# DEVIATION REQUEST AND DECISION FORM IN ASSOCIATION WITH A REQUEST FOR A PUD MODIFICATION FROM THE ECM

PROJECT INFORMATION		
Project Name :	Waterside	
Schedule No.(s) :	71114-04-112	
Legal Description :	All of the waterside condominiums subdivision, recorded in Plat Book 2, At Page 47 Records of El Paso County, Colorado

# PROPOSED TYPICAL SECTION - PRIVATE ROADWAY TRACT

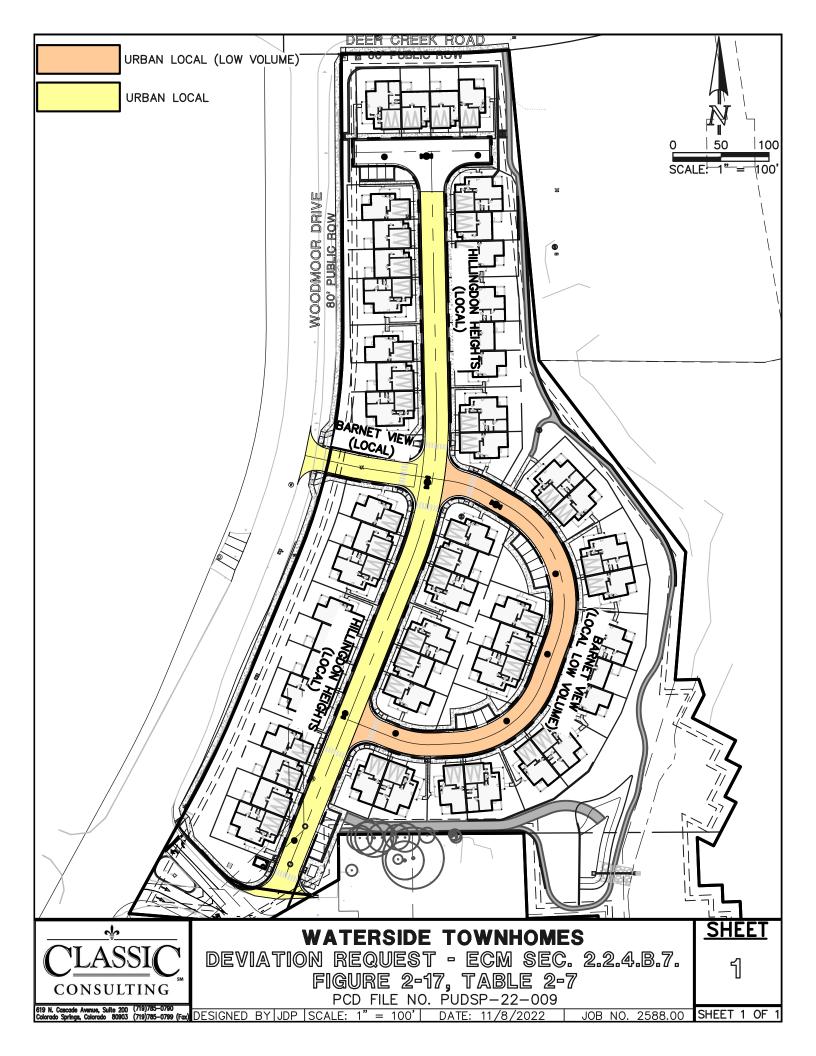
Add deviation request for tangent length for broken back curves and pavement width into this request. Local low volume road still needs to meet tangent length for a local road and the local road portions need the deviation from a standard 30' wide asphalt mat. ECM administration designee has no issues with the proposed deviations, they just need to be properly documented within the project file. If there are additional questions in regards to this, please let reach out.

Callout (1)		
with a 50 mints apphale max. Any provide applicable regional or national standar uptor of any price 30 - 40 regional maximum red by the homeover's Association) and includes a 30 any, upgrage and warrent thickness, as well a submit which depicting locations of urban local and urban local which depicting locations of urban local and urban local	Subject: Callout Page Label: 3 Author: CDurham Date: 12/15/2022 9:42:18 AM Status: Color: Layer: Space:	with a 30' wide asphalt mat.
Highlight (2)		
າ a 29′ wide be <mark> bult</mark> usi See attach	Subject: Highlight Page Label: 3 Author: CDurham Date: 12/15/2022 9:42:29 AM Status: Color: Layer: Space:	bult
de private tract ( sing country star hed proposed st	Subject: Highlight Page Label: 3 Author: CDurham Date: 12/15/2022 9:42:32 AM Status: Color: Layer: Space:	country
Text Box (1)		
In the second	Subject: Text Box Page Label: 1 Author: CDurham Date: 12/15/2022 9:46:58 AM Status: Color: Layer: Space:	Add deviation request for tangent length for broken back curves and pavement width into this request. Local low volume road still needs to meet tangent length for a local road and the local road portions need the deviation from a standard 30' wide asphalt mat. ECM administration designee has no issues with

ECM administration designee has no issues with the proposed deviations, they just need to be properly documented within the project file. If there are additional questions in regards to this, please let reach out.
